UNITED STATES  
NUCLEAR REGULATORY COMMISSION  
WASHINGTON, D. C. 20555

August 30, 1979

This will confirm my request to you on the telephone today that Babcock and Wilcox provide us with copies of the Site Problem Reports and Preliminary Safety Concerns listed below.

TITLE Pressurizer EMO Relief initted Inadvertently  
RELATED SPRs \_\_\_\_\_

FIG 8

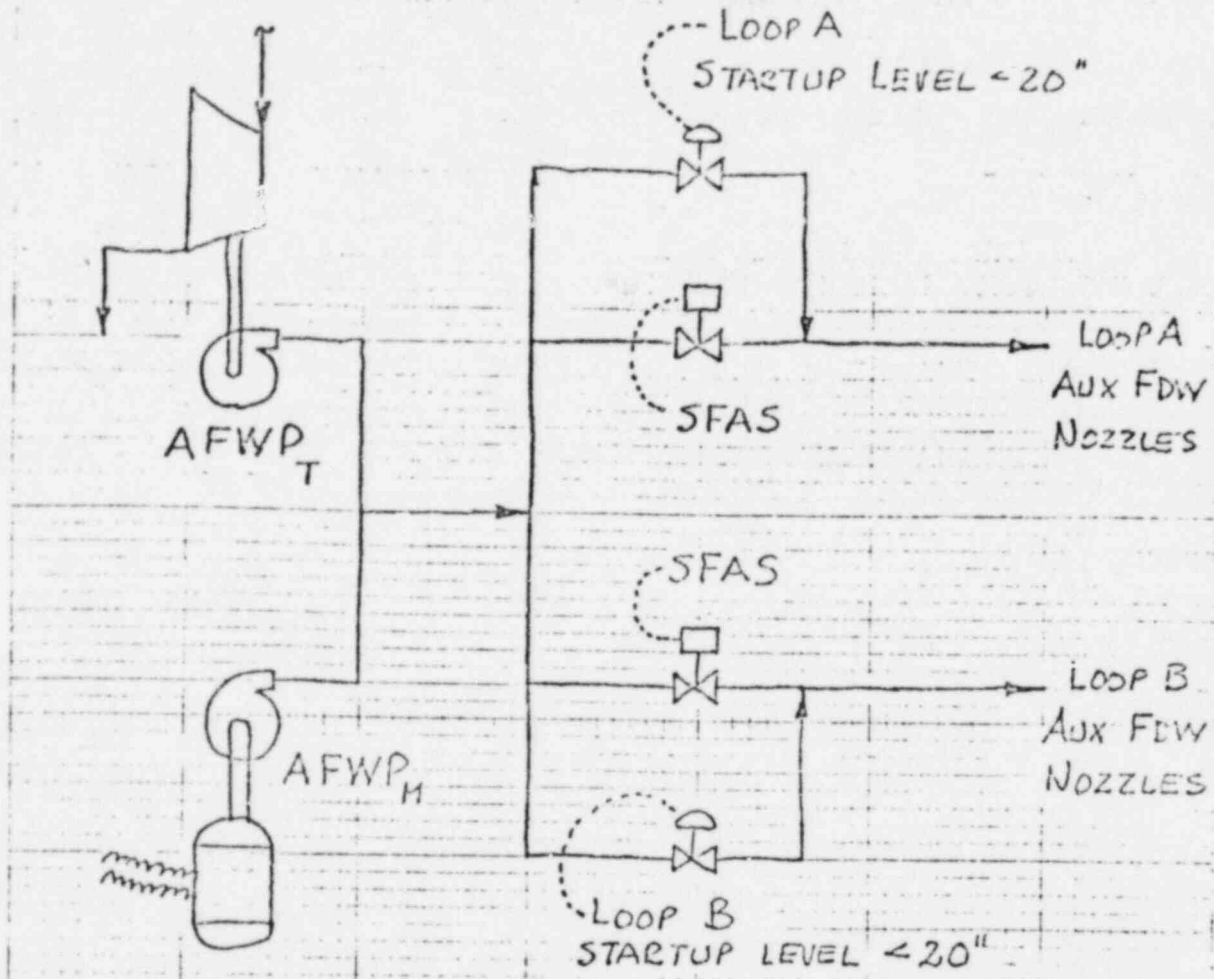
3. At 13 minutes after the reactor trip the SFAS was initiated by PC pressure dropping below 1100 psig. It opened both Loop A and B motor operated valves, See Figure 8, and water flowed to both Steam Generators.

FIGURE 4

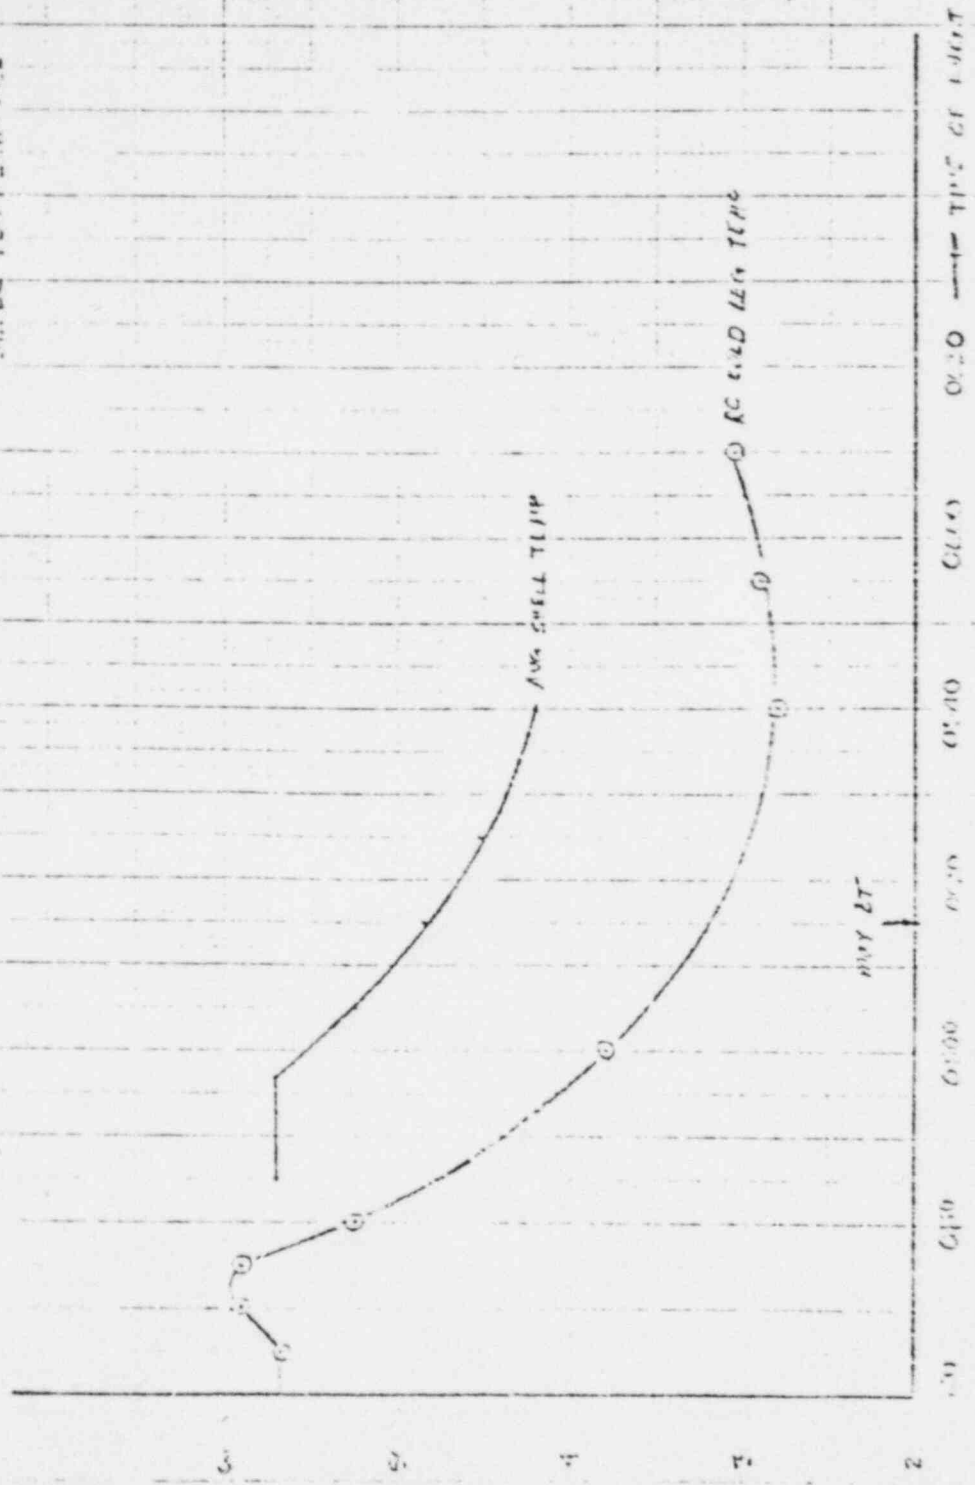
To assess whether or not the tube yield strength was exceeded during this transient, an estimate of average shell temperature vs. time was made. A plot of the average shell temperature as calculated is shown in Figure 4. From this calculation, the maximum tube-to-shell temperature differential ( $\Delta T$ ) is 170°F at 0515 hours. (Note that average tube temperature is equal to RC cold leg temperature.) This information was transmitted verbally to C. W. Bruny at Mt. Vernon who subsequently determined that 170°F tube-to-shell  $\Delta T$  does not result in a tube stress greater than yield. Based on this information and on our judgement that the calculated average shell temperature is conservative, we concluded that the tube stress did not exceed yield and that the tubes were not plastically deformed. Due to the preliminary nature of this assessment, however, we advised that plant operation be restricted to 75% power pending QA of the calculations.
